Ladder Bending Tests

BPAC Concerns & Recommendations

- Concerns

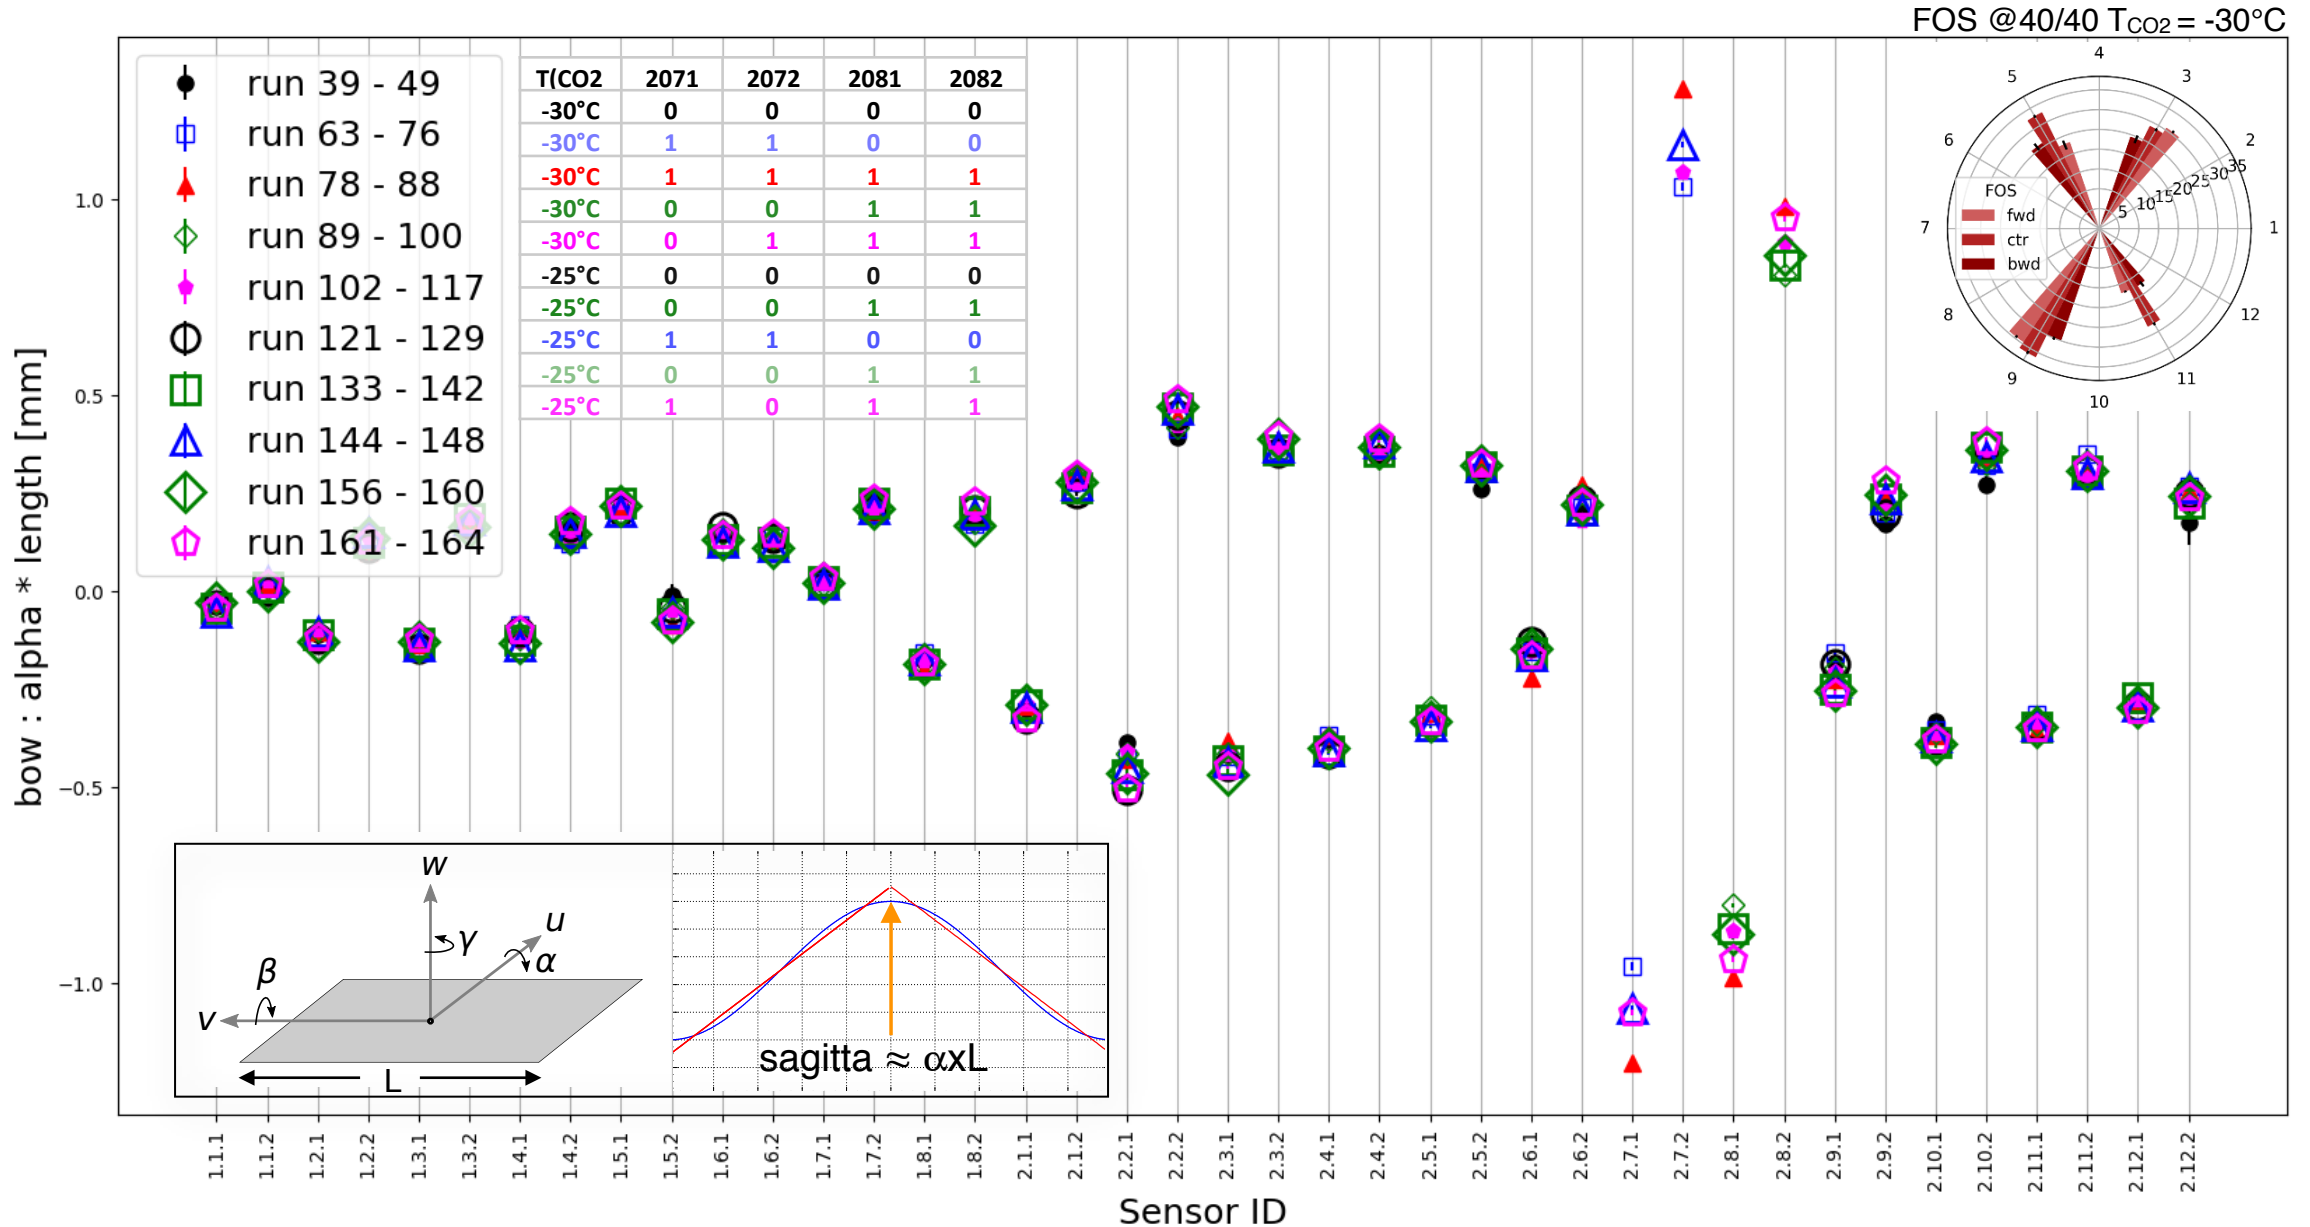
- The bowing of ladders and the open issue of how to power the ladders remain a concern. At our last review it was suggested that a small working group of experts of the affected systems be appointed to evaluate the full impact of this change. At this brief review no update was provided.
- The grounding of the PXD2 to the beam pipe seems to have no adverse effect, but further studies seem warranted.
- Preservation of the knowledge, which lead to the successful installation of the detector needs to be guaranteed.

- Continue to study the ladder bowing as best as possible, understand its behaviour and develop mitigation strategies.
- Decide, after careful study, a safe operating temperature of the detector.
- Document in full detail the as-built PXD2 detector (repeat of the July recommendation)
